RE: Representations relating to the Draft Lam Tei and Yick Yuen Outline Zoning Plan (OZP) No. S/TM-LTY Y/11

Regarding the captioned, The Conservancy Association (CA) would like to express concern on the proposed amendments Item A.

Figure 2 Approximate location of the tree group *Litchi chinensis* (circled in red in red)

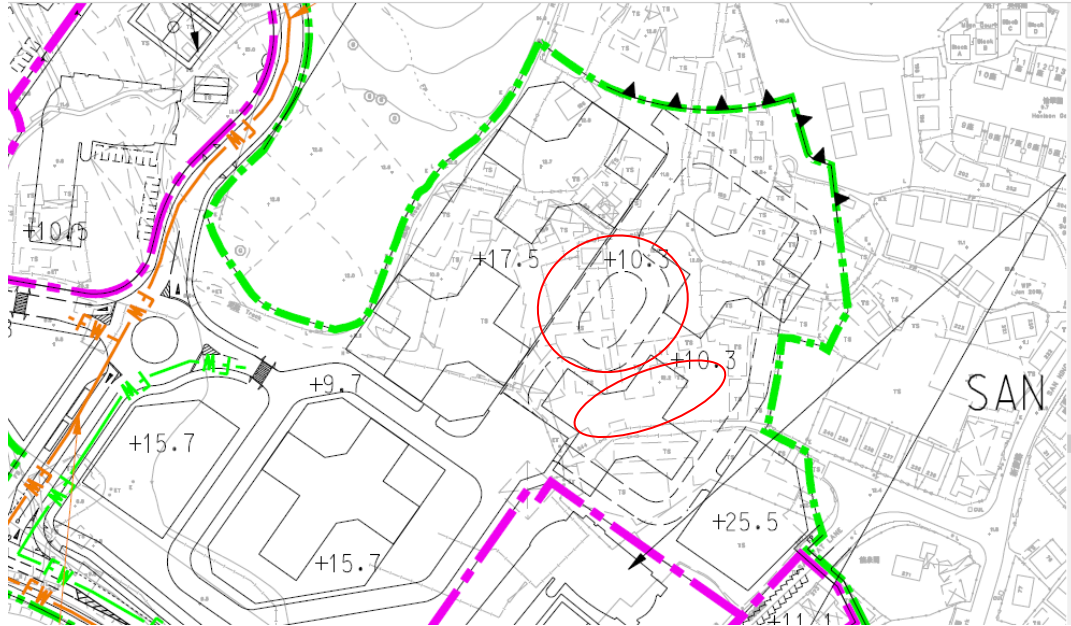
From our site observation, a group of *Litchi chinensis* are located within the proposed development site (Figure 2-6). They are 6-8m in height, and 0.5-0.6m in DBH. Such observation is similar with the result of broad brush tree survey; Landscape and visual impact assessment in the EIA Report.

Currently this tree group would be directly affected 2 residential blocks and new road. While existing mechanism for tree compensation would be strictly followed to meet the target of tree compensation, it would not help preserve individual trees with high maturity and amenity value. Viewing that it is relatively high in maturity and amenity value within the proposed development site, a review on the development plan, such as development scale, urban design, tree transplantation plan, is necessary to avoid direct felling those trees.
